# 8th Edition (2023) Florida Building Code

**Proposed Code Modifications**

## **ROOFING DETAIL**

# TAC: Roofing

Figure 6.1

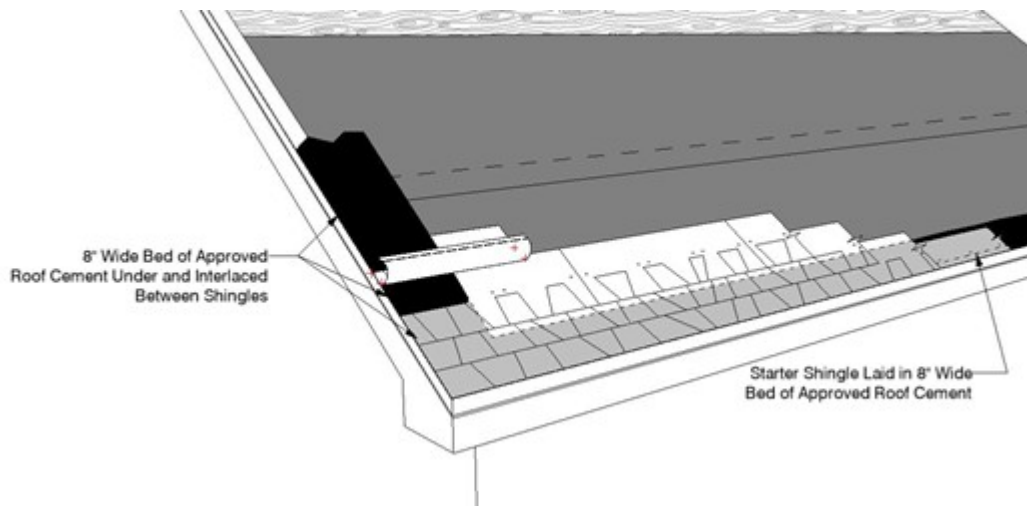
**Add New Figure 6.1:**

**DRAWING 10**  
**EAVE TILE DETAIL**  
**EPDM EAVE CLOSURE**

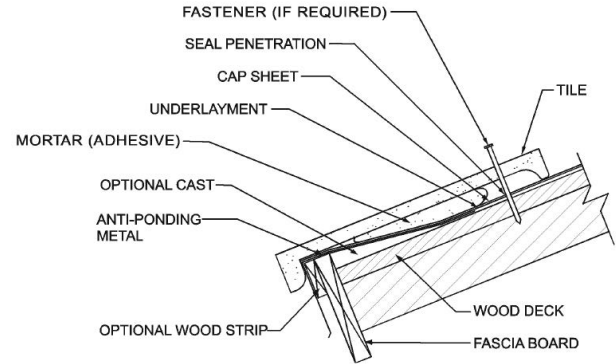
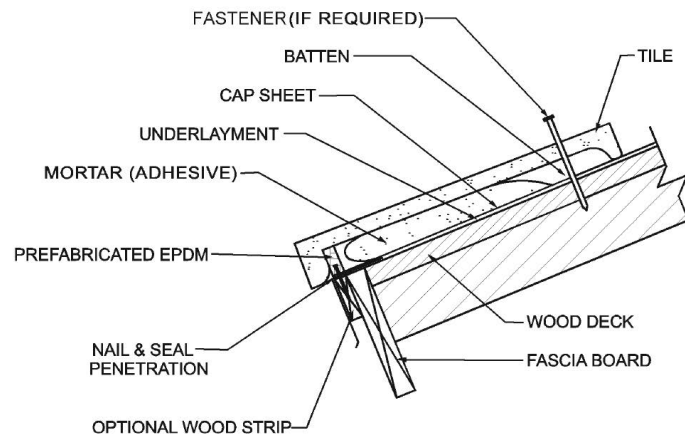
The images for Drawing 10 and Drawing 12 need to be swapped. Drawing 10 detail shows anti-ponding metal instead of EPDM Eave Closure. Drawing 12 shows EPDM metal instead of Anti-Ponding Metal.

Just correcting a typo error.

**FIGURE 1**

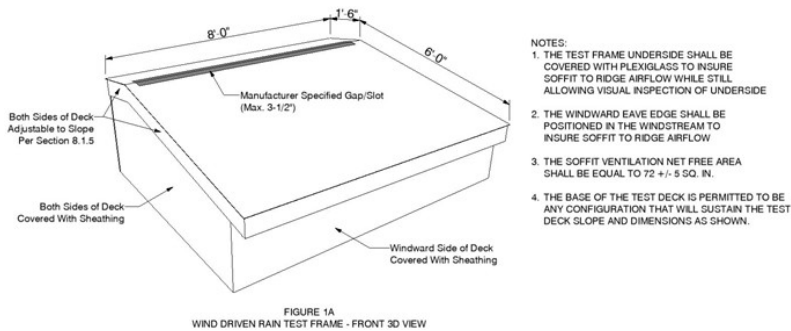
A replacement for Figure 1 is proposed. The new drawing is properly proportioned, includes correct dimensions, and more accurately represents the test deck that is used. Section 8.1.2 is modified to clarify how adjustments to slope are made. Finally, the edition of TAS 100 is updated. TAS 100 has been modified in previous cycles, but the edition was not updated when that occurred.

Replace existing Figure 1 with this version.

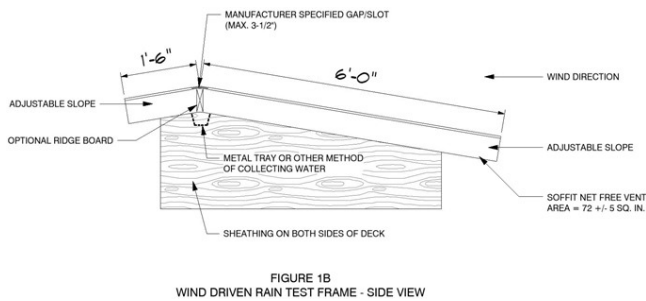
This MOD replaces Figures 1A and 1B with new illustrations that are properly proportioned and more accurately represent the test deck that is used. Details about the test deck are relocated from Section 5 into Section 8 and additional clarifications—including acknowledgement that other methods besides a metal tray are permitted for collection of water—are proposed in Section 8 to align the text and Figures. Finally, the edition of TAS 100(A) is updated in conjunction with this change. TAS 100(A) has been modified in previous cycles, but the edition was not updated when that occurred.

Replace existing Figure 1A with this version.

Replace existing Figure 1B with this version.
